Swanzey Planning Board Agenda
June 25, 2026
6:00 PM

Memorandum – Office of Planning and Economic Development

Terry Lewis has submitted a Site Plan Review application to utilize an existing 1,600-square-foot Detached Accessory Dwelling Unit (DADU) as a commercial event and wellness space. Proposed activities include healing circles, yoga, meditation, retreats, and herbal classes.

Location: Northeast side of NH Route 12, abutting the Cheshire Rail Trail and directly across from the Cheshire Fairgrounds.
Parcel ID: Tax Map 209, Lot 11.
Acreage: ±57 acres.
Frontage: ±325 feet of road frontage along James Road.
Site Access: Entrance is located at the eastern terminus of James Road.
Zoning Districts: Business District (primary); Wetlands Conservation District (portions)
Water & Septic: Property has an approved septic plan for all dwellings (residential use only). Water is accessed from on-site well.

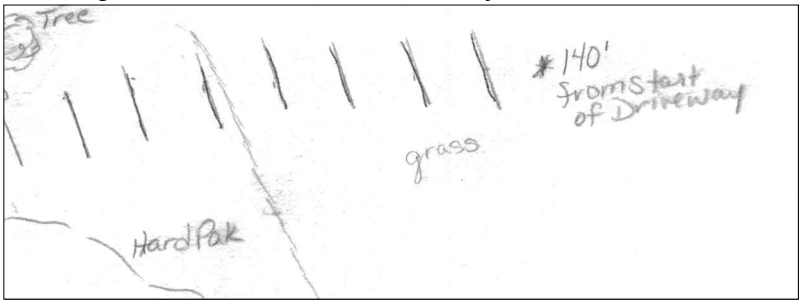
- *Grassy area shown on north side of lot should not be used as parking.*

Site Plan

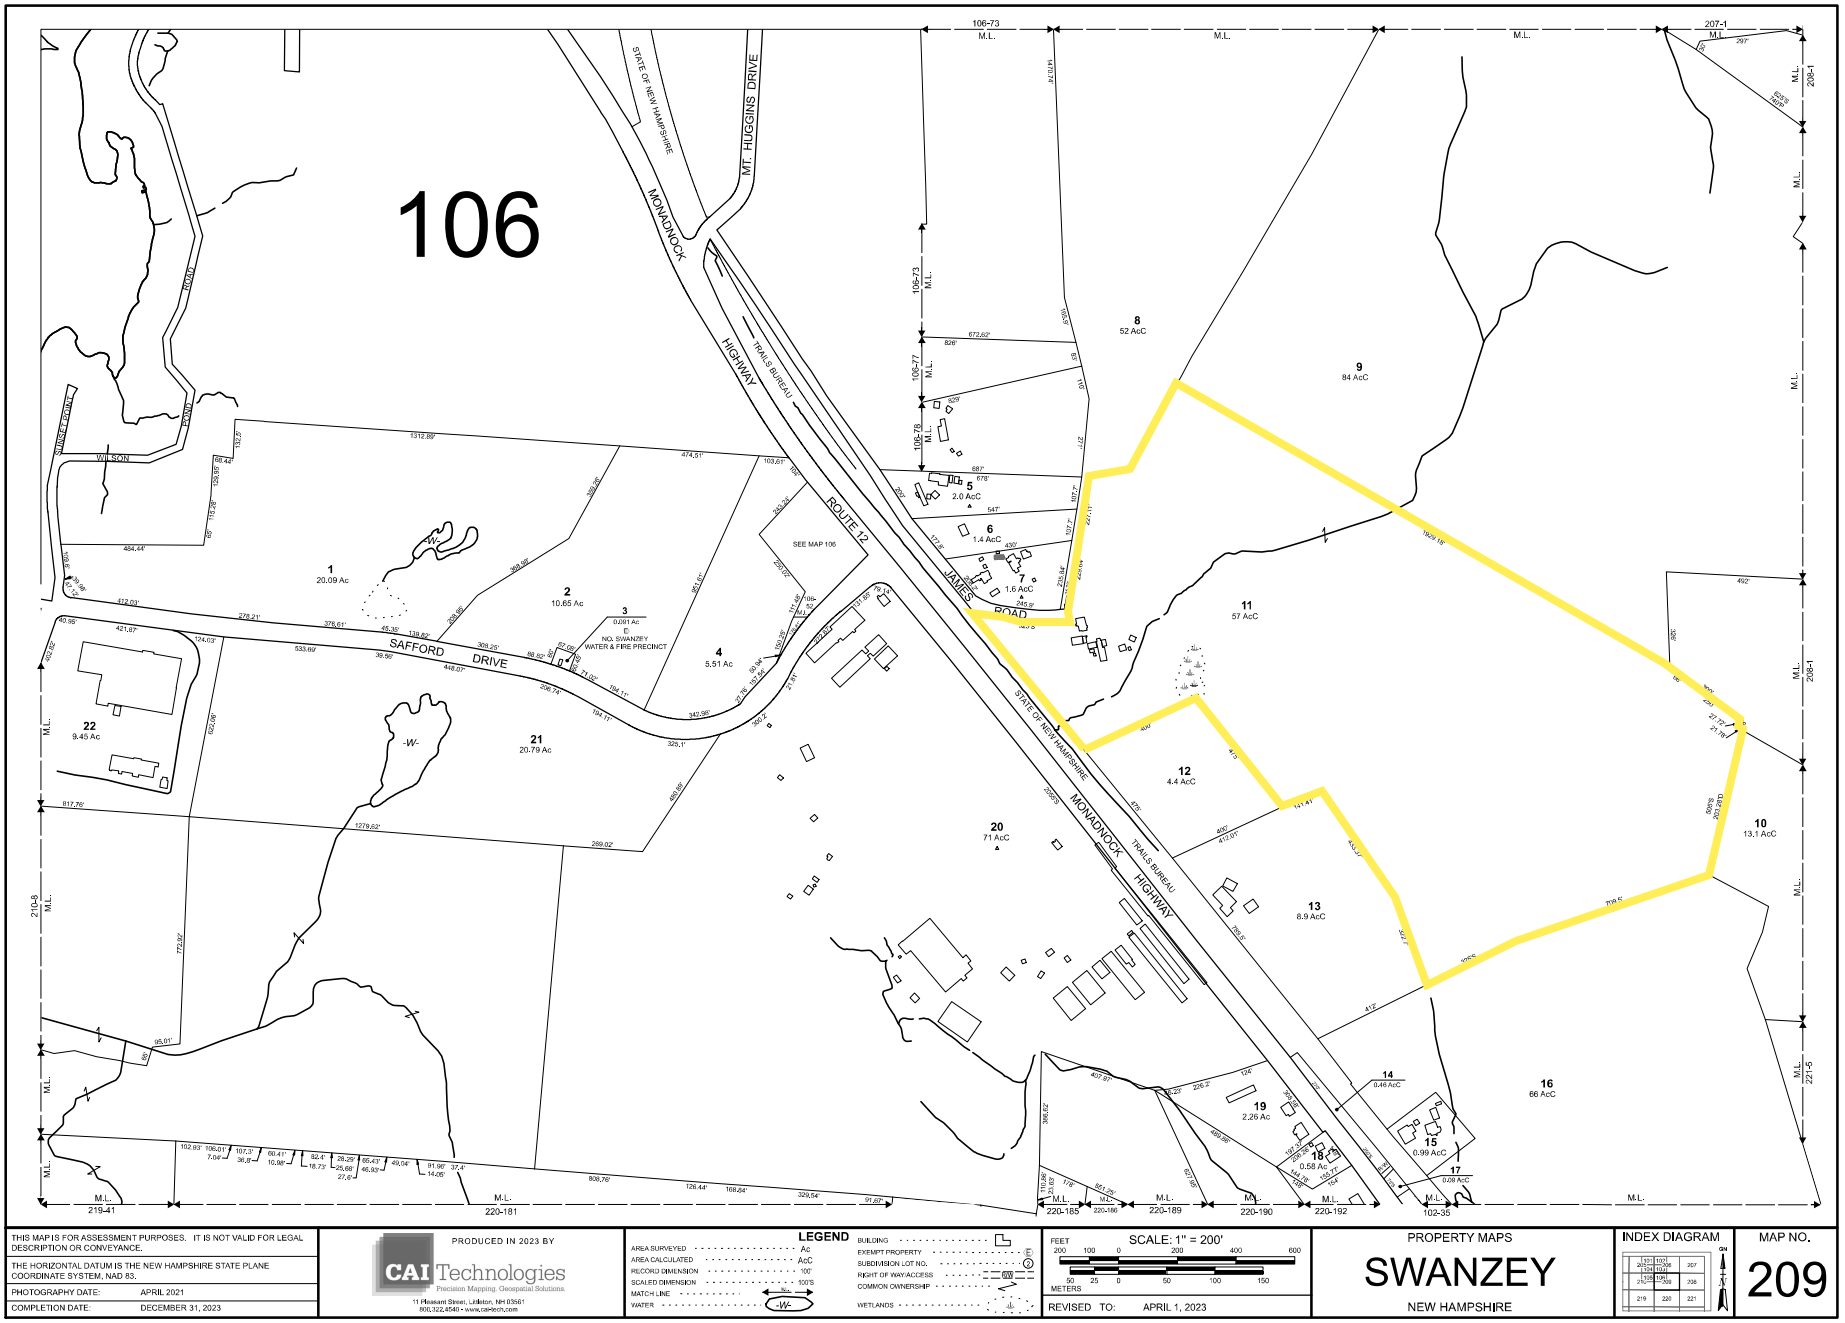
1. Plans should show existing and proposed conditions.
2. Plans should show boundary lines of property.
3. Parking areas should conform to Section VIII Article 2 of the Site Plan Review Regulations. Detailed notes above.
4. Water and sewage should conform to Section VIII Article 6 of the Site Plan Review Regulations. Detailed notes above.
    a. The provided septic plan is not sufficient for commercial use.
5. Handicapped access should be provided per Section VIII Article 10 of the Site Plan Review Regulations.
6. Handicapped parking should be provided per federal ADA standards.
    a. https://www.ada.gov/topics/parking/
7. Final plans should be printed on regular paper so it stores well in filing cabinets. Tracing paper can lose clarity with years in storage.

8. Staff are concerned about the project's proximity to a stream. Plans should clearly delineate this stream. If the project is within the Shoreland Protection District, it will need additional applications with the Zoning Board.
9. The Conservation Commission should review this application prior to any approvals. Or approvals should be conditioned upon Conservation Commission approval.

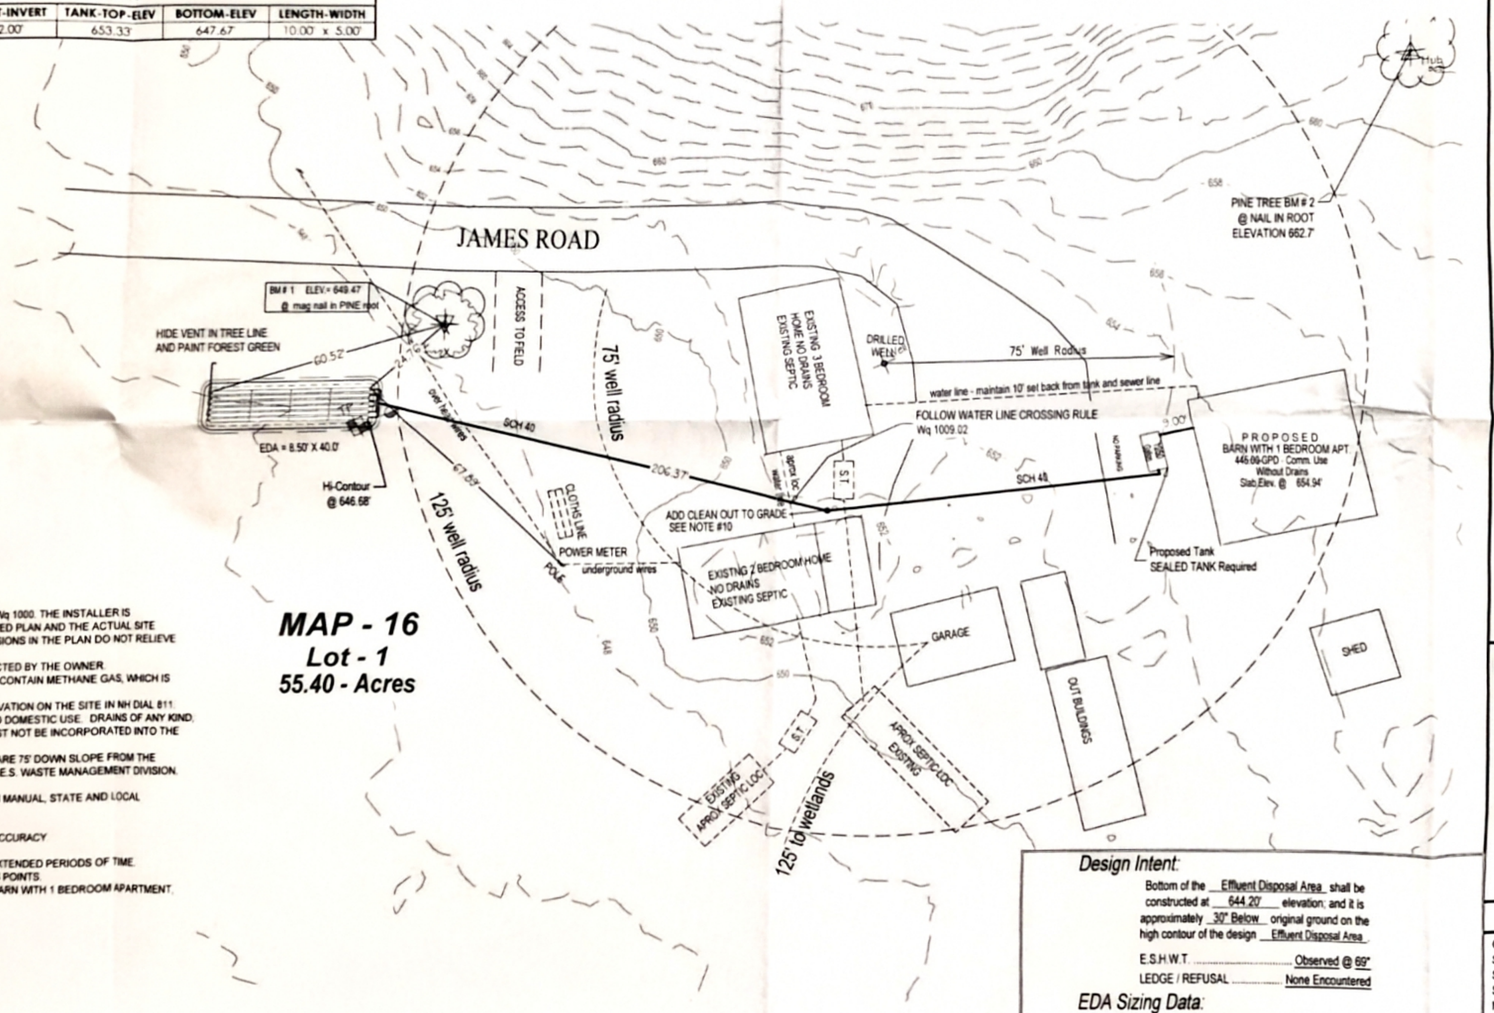
> *- The septic plan states that the use of the system is intended and designed strictly for normal household domestic use. Thus, the current system is inadequate for commercial use.*
